**LEGAL ADVERTISEMENT
PORTLAND PLANNING BOARD**

The Portland Planning Board will hold a meeting on Tuesday, October 9, 2018, Council Chambers, 2nd Floor, City Hall, 389 Congress Street. Public comments will be taken for each item on the agenda during the estimated allotted time and written comments should be submitted to planningboard@portlandmaine.gov

- i. Level III Site Plan; 90 Johnson Road; Transport Leasing Corp., Applicant. (4:30 - 5:15 p.m. estimated time) The Board will hold a workshop to consider the redevelopment and expansion of the existing office/warehouse building. Two stories will be added to the existing 17,482 sf building for a total area of 39,546 sf for office space. Access to the 2.66 acre site will be from Johnson Road and City Line Drive and a parking area for 188 vehicles is proposed. The project is proposed in two phases with the parking area being the first phase. The site is in the B-4 Commercial Business Zone and is subject to review under Portland's Site Plan Standards.

- ii. Level III Site Plan and Subdivision; 130 Bancroft Street; Joshua Wagner, representing WB Group, Inc., Applicant. (8:00 – 8:45 p.m. estimated time) The Board will hold a public he

(C) POROUS PAVEMENT SECTION
N.T.S.

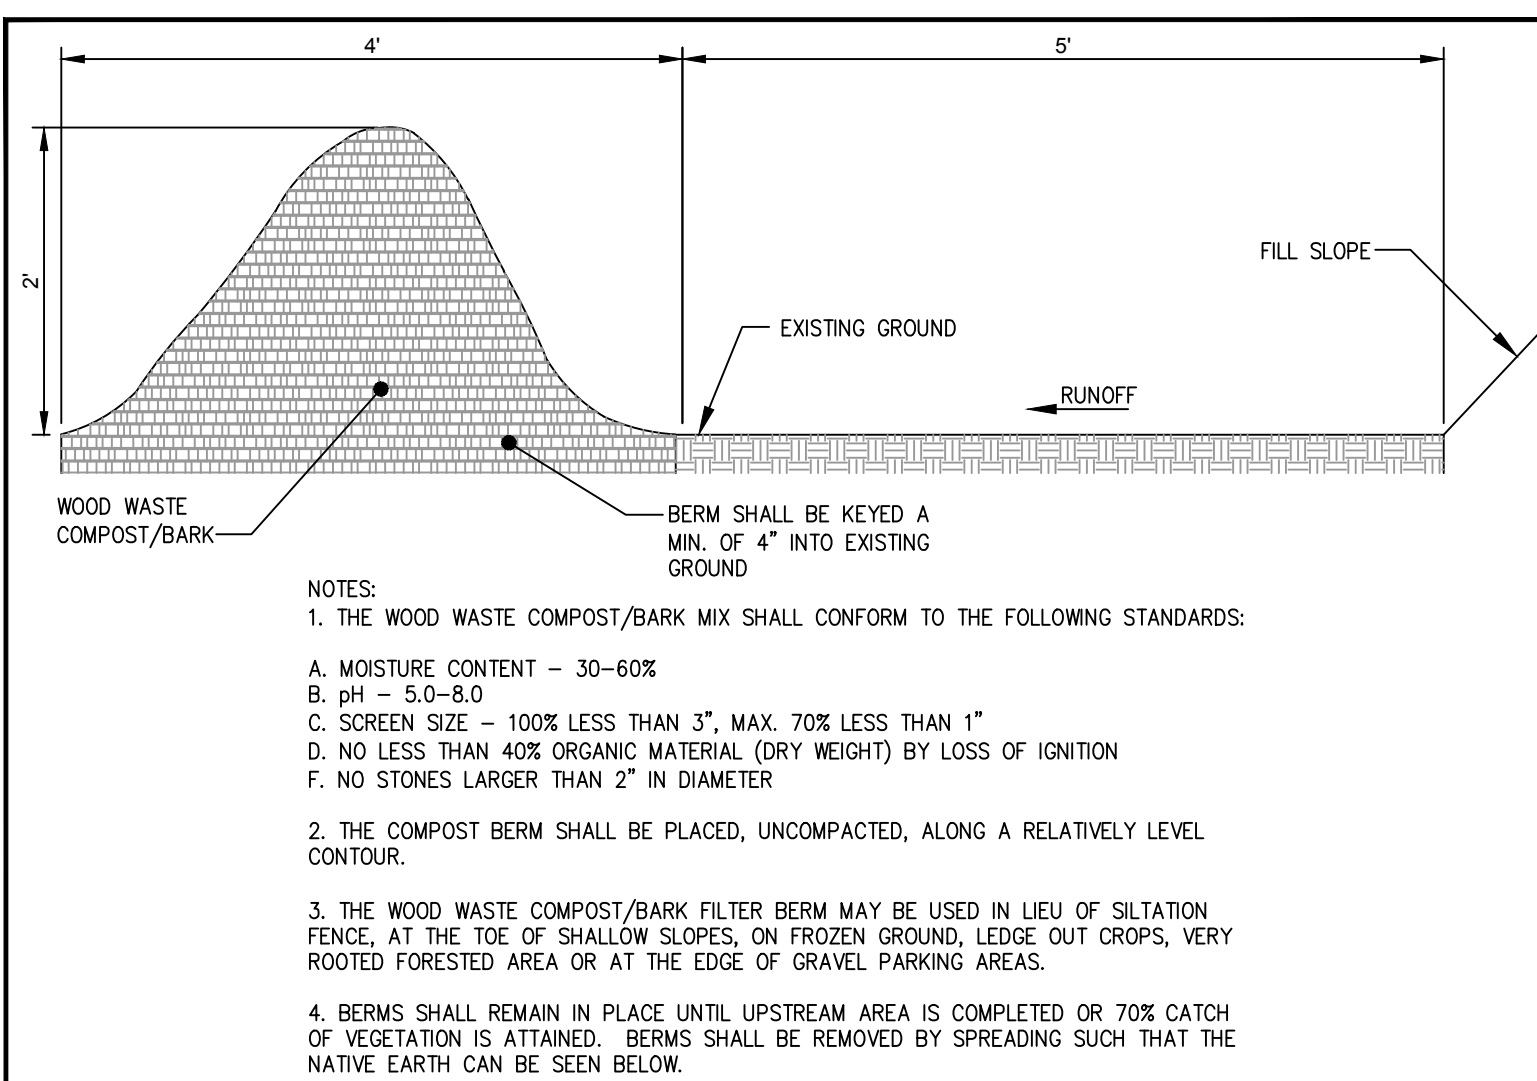
Details describing orifice installation have been added to Plan Sheet C-8.2. A section regarding orifice maintenance has been added into the Operations and Maintenance Manual that accompanies this response letter.
